TOWN OF LAKEVILLE MEETING POSTING & AGENDA

Name of Board or Committee:	Planning Board
Date & Time of Meeting:	Thursday, June 22, 2023 at 7:00 p.m.
Location of Meeting:	Lakeville Police Station 323 Bedford Street, Lakeville, MA 02347
Clerk/Board Member posting notice:	Cathy Murray

RE: 44 Clear Pond Road
Response to Peer Review Comments and Revised Definitive Subdivision Submittal

L-2

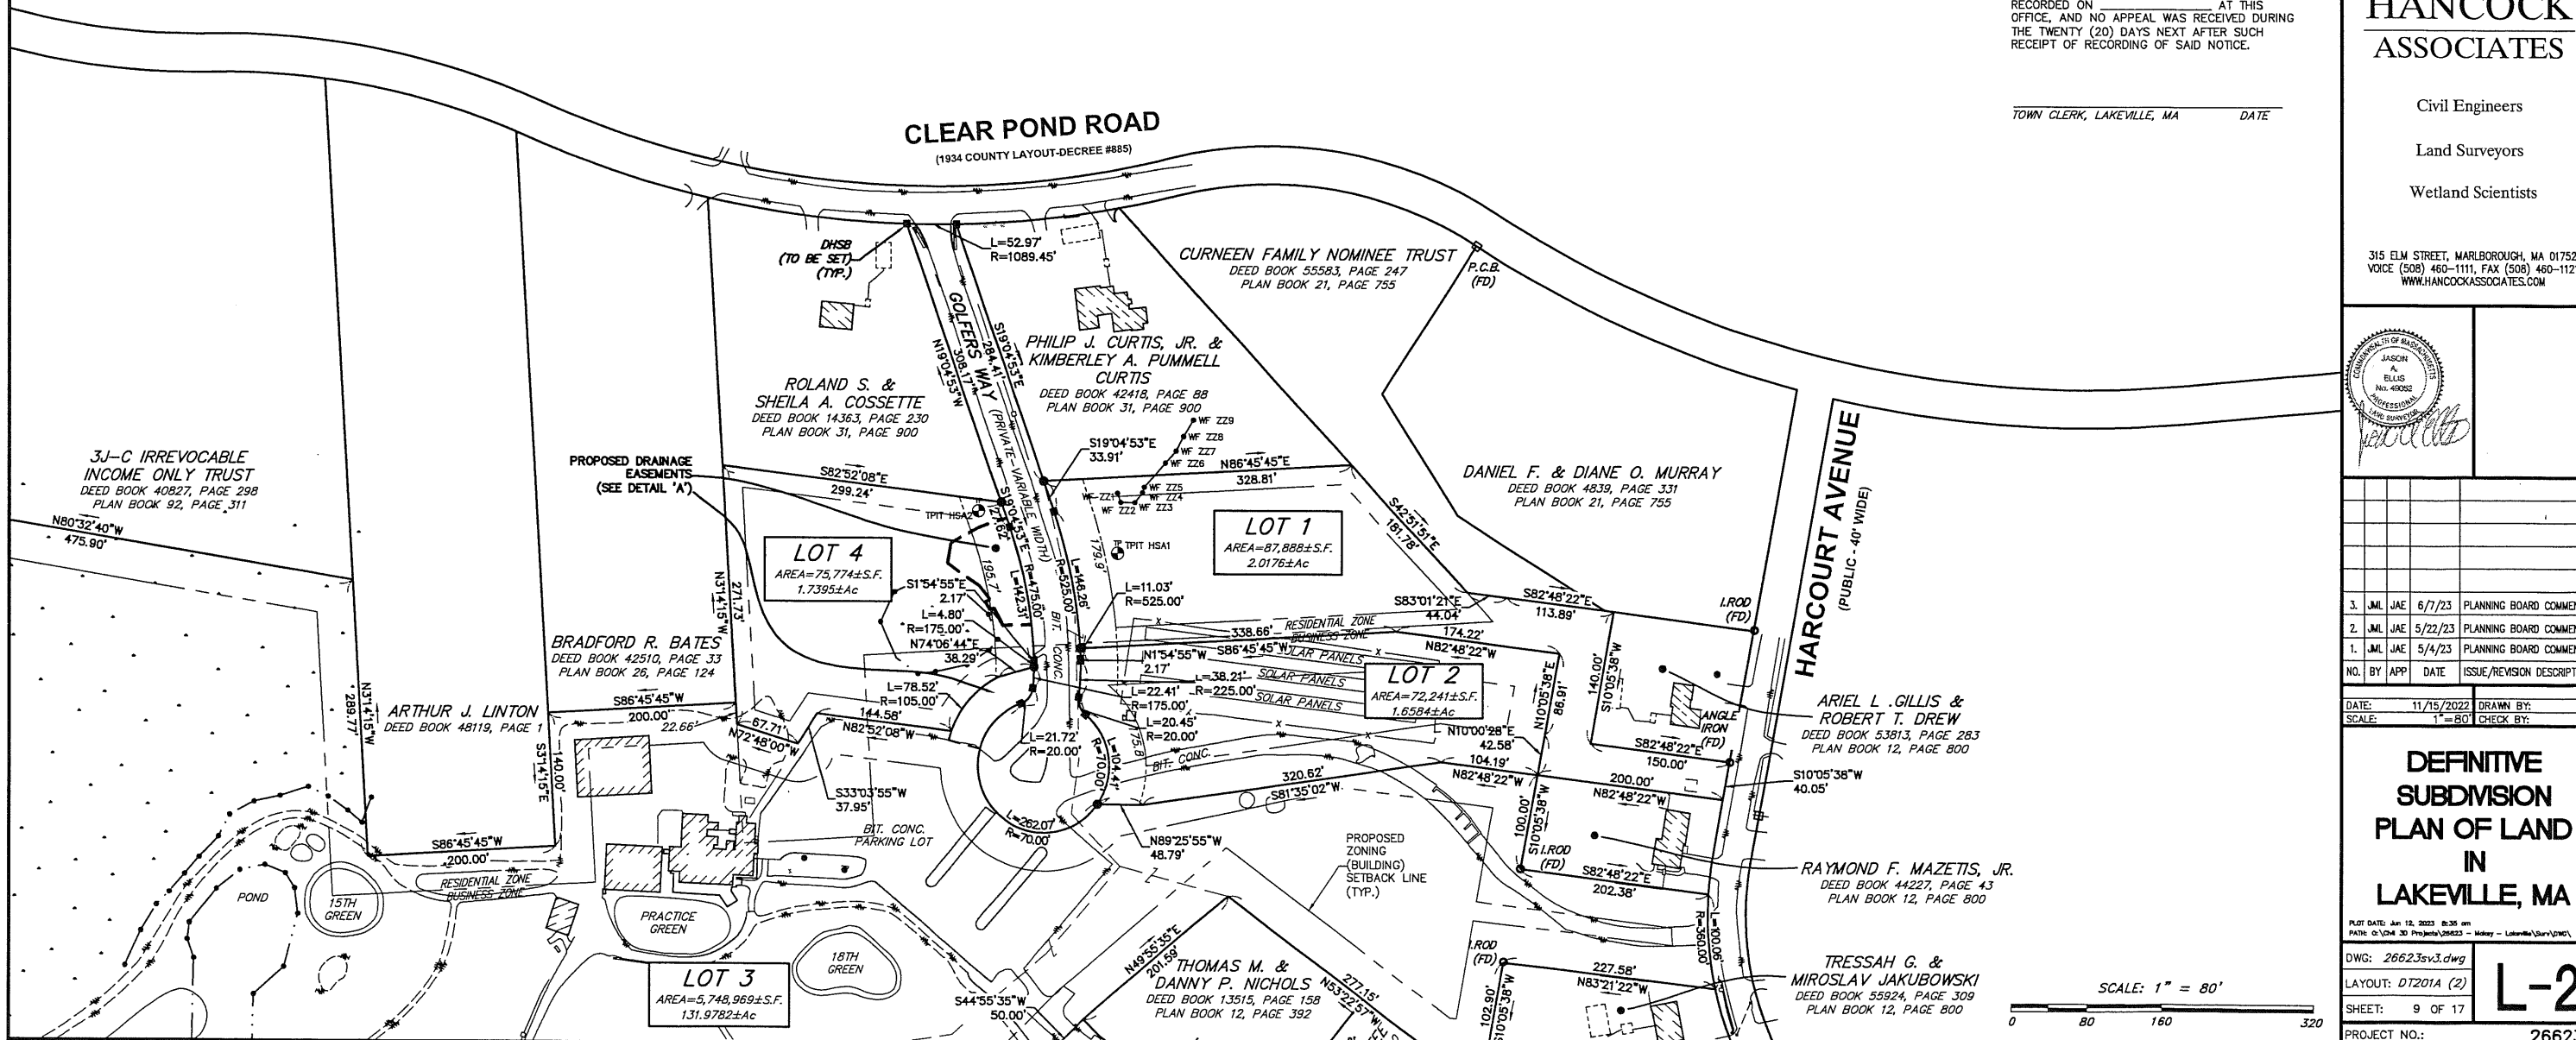
3. Section III.C.2.k requires building setbacks be shown on the plans. We did not see building setback lines on the plans.

Proposed monuments were shown on Sheet L-2 as a dark square and labeled "DHSB" (To Be Set)(Typ.), for clarity a Proposed Legend has been added to Sheet L-2 identifying the symbols for proposed monumentation (stone bounds and iron rods).

Building setback lines were shown on Sheets L-1 through L-6 and labeled "Zoning Setback Line (Typ.)", for clarity the line symbol and label have been added to the Proposed Legend on Sheet L-2.

PLAN AND PROFILE

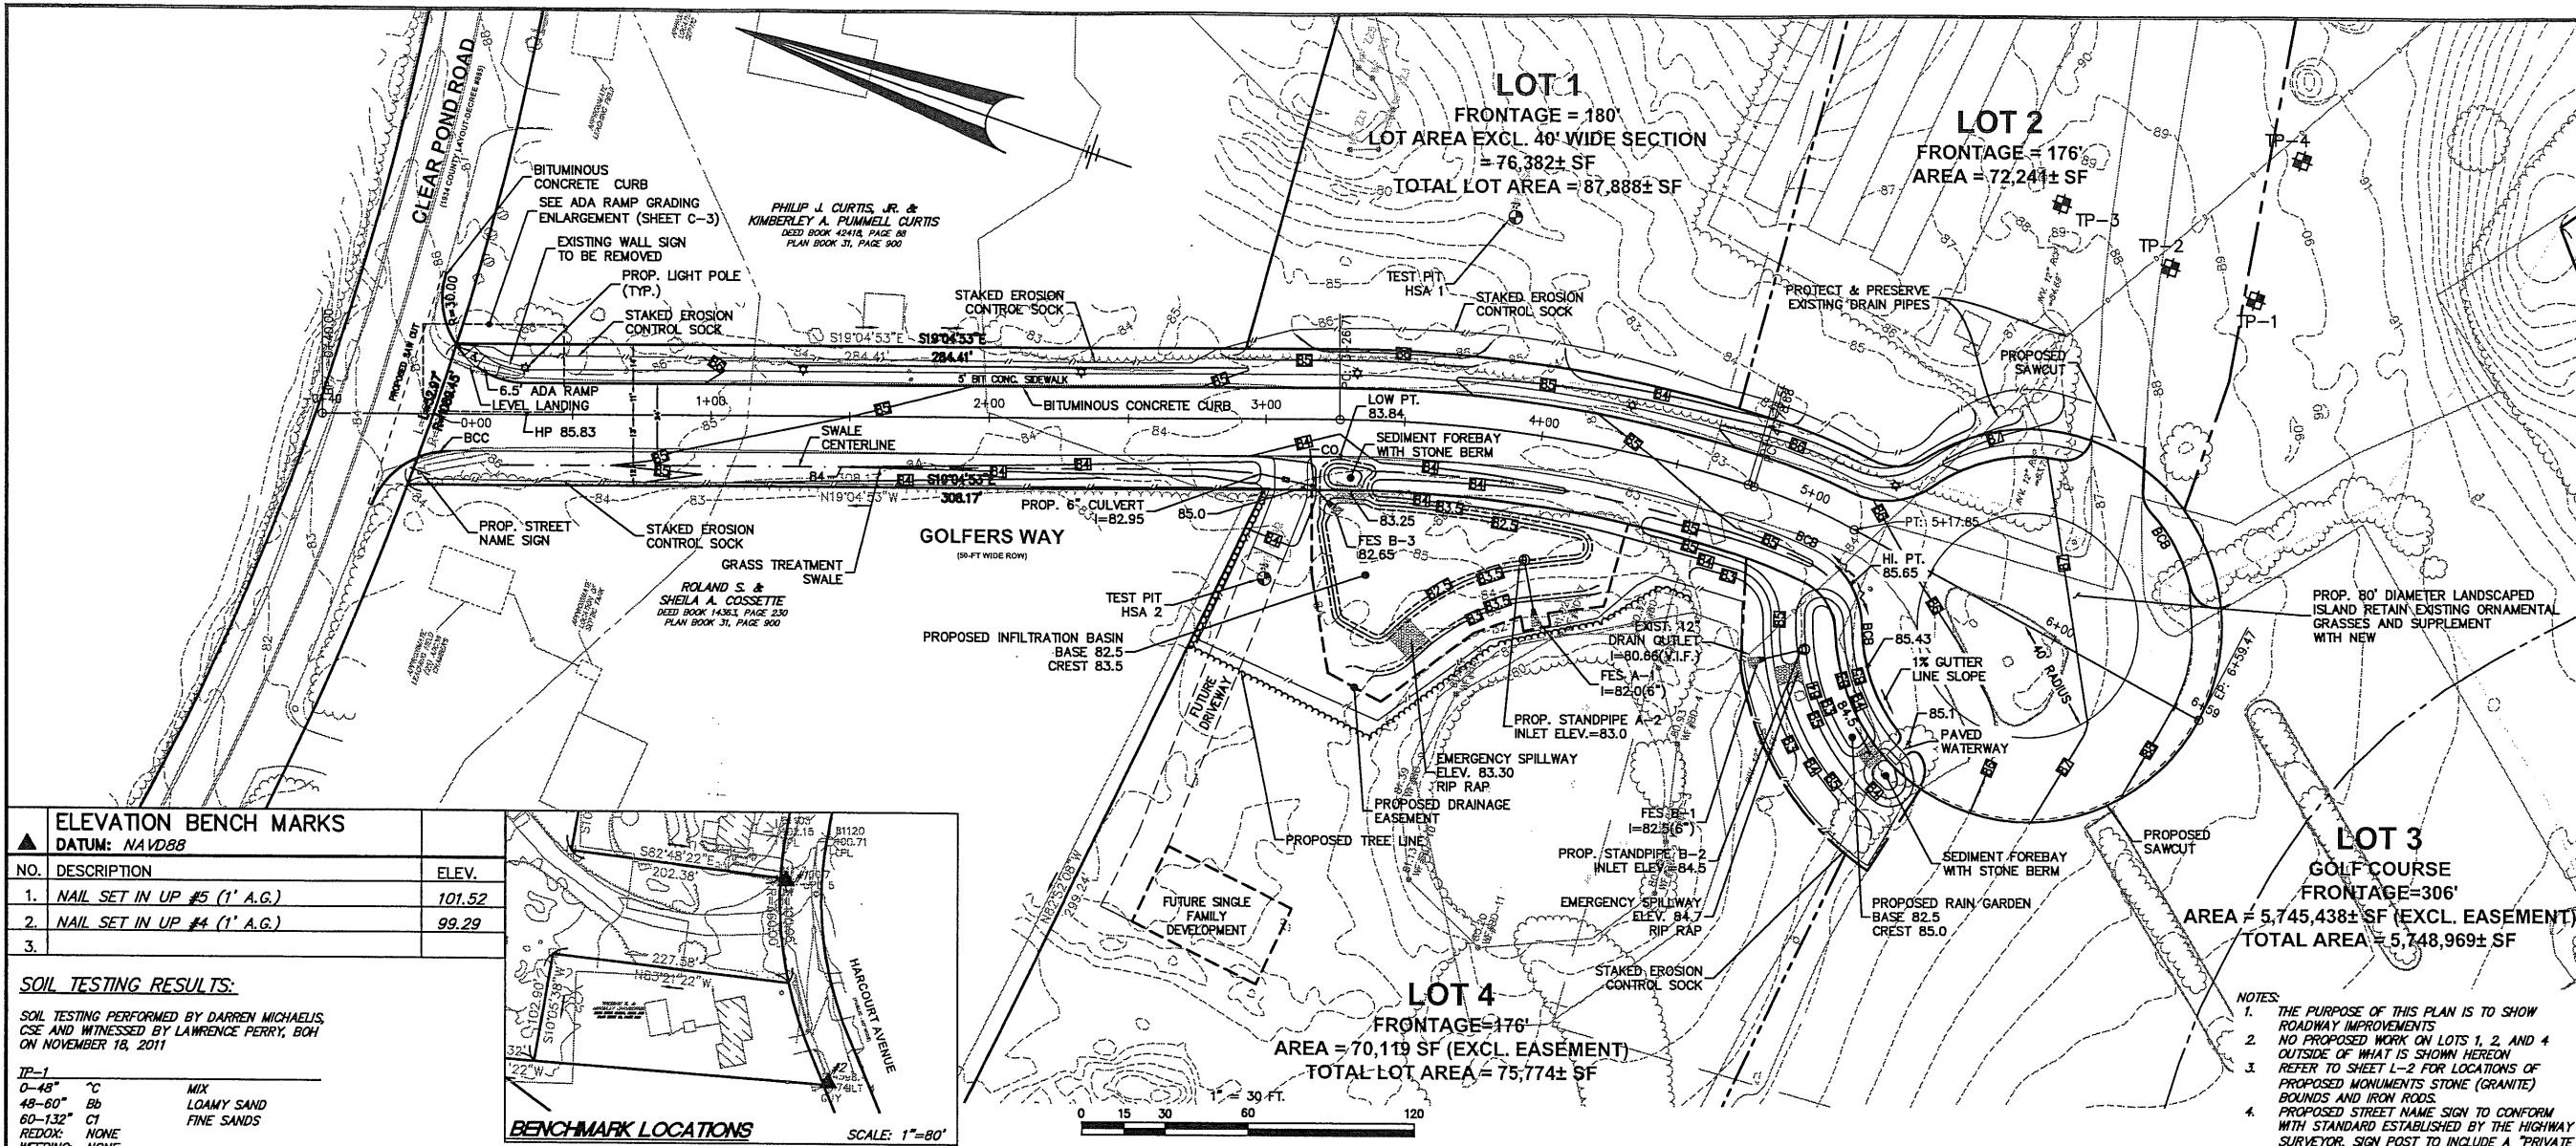
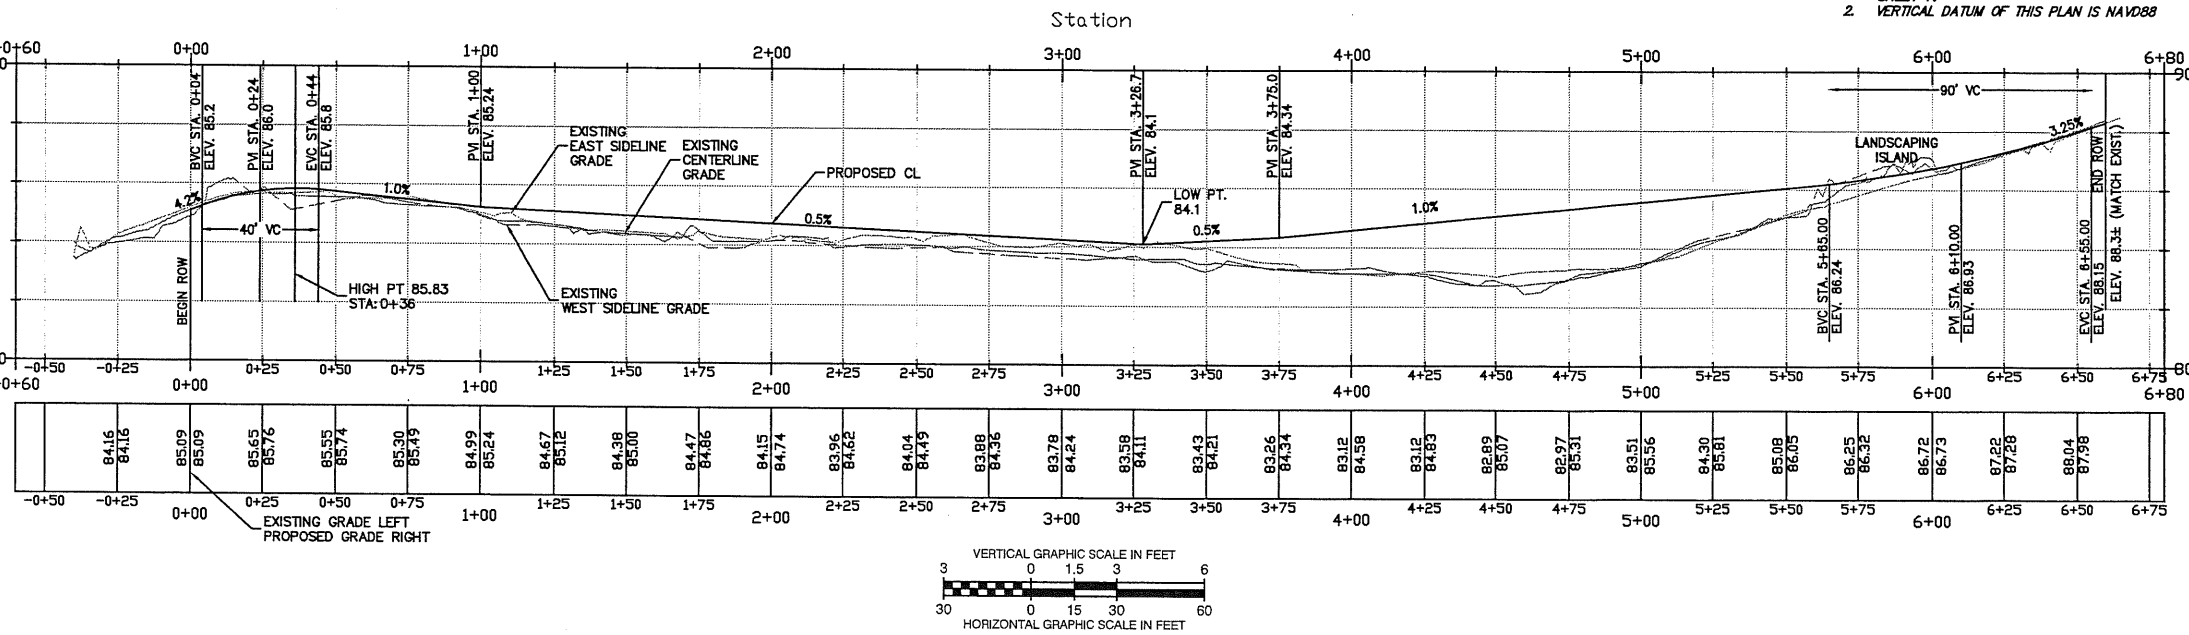
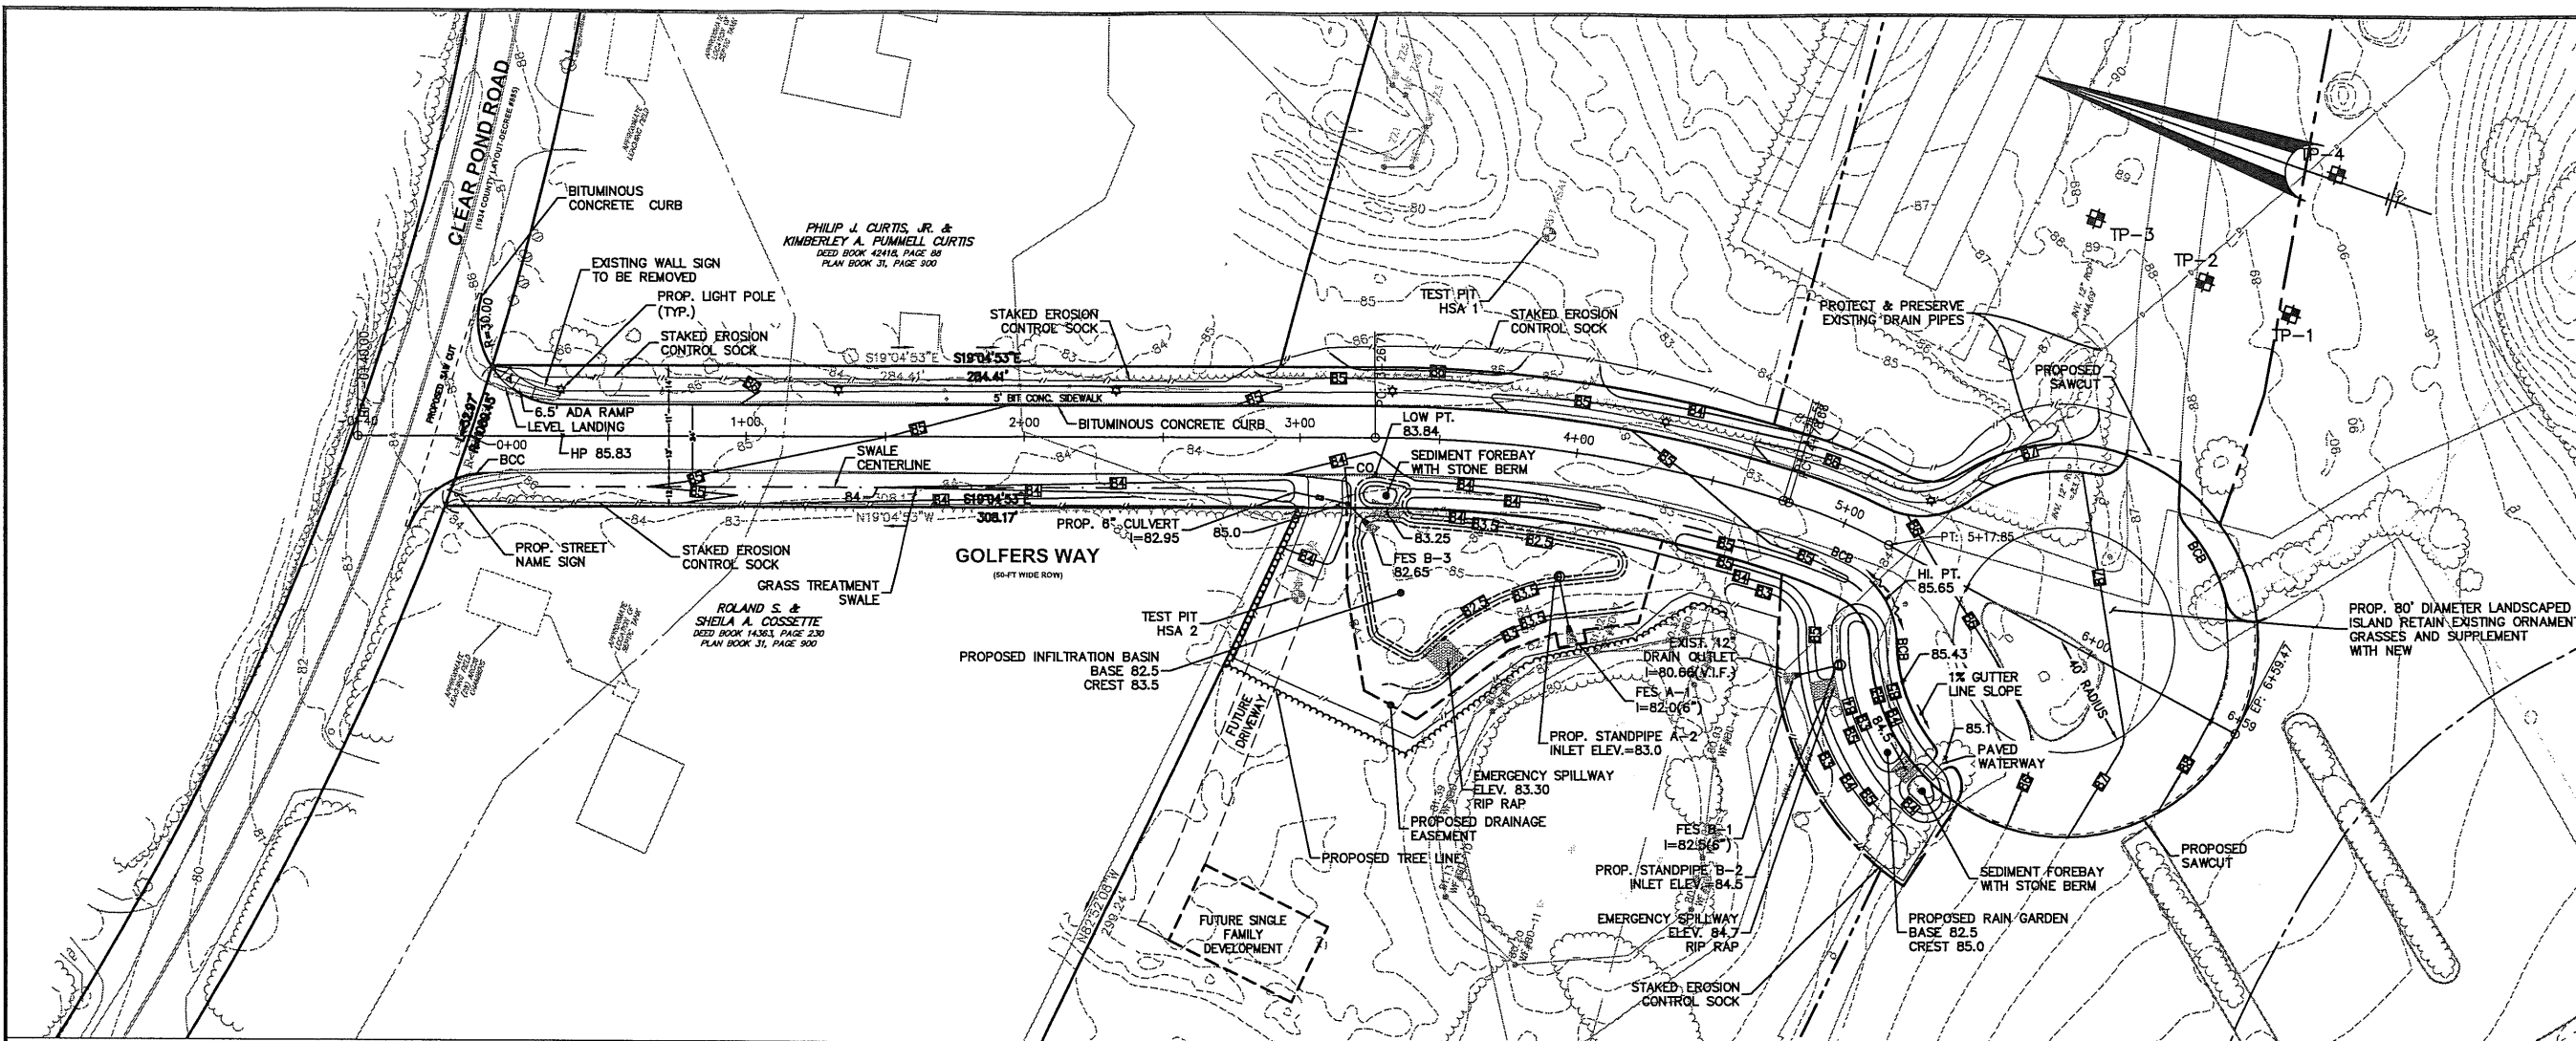
1. Section III.C.2.b requires benchmarks to be included on the plans. There is a reference to a benchmark on sheet C-1 but we were unable to find the benchmark on the plans.

4. Section III.C.2.p requires two benchmarks be shown on the plan and profile sheets. The plan and profile sheet includes a reference to a benchmark but no actual benchmarks.

9. Section IV.B.4.c requires vertical curves where the change in grade exceeds 1%. There is a low point on the road with a change of grade of 1.5% that does not include a vertical curve.

19. Section IV.H requires street signs to be installed. The proposed plans do not show street signs.

As noted Sheet C-1 included a note referring to Existing Conditions Sheet EC-6 for benchmark locations and elevations. Sheet C-1 has been revised to also show the benchmark locations and elevations to address this comment.

The Plan and Profile Sheet (Sheet C-1) has been revised to show the benchmark locations and elevations.

The proposed centerline profile has been revised to address this comment.

Sheet C-1 has been revised to include a street name sign in plan view and also spell out the requirement in Note 4.
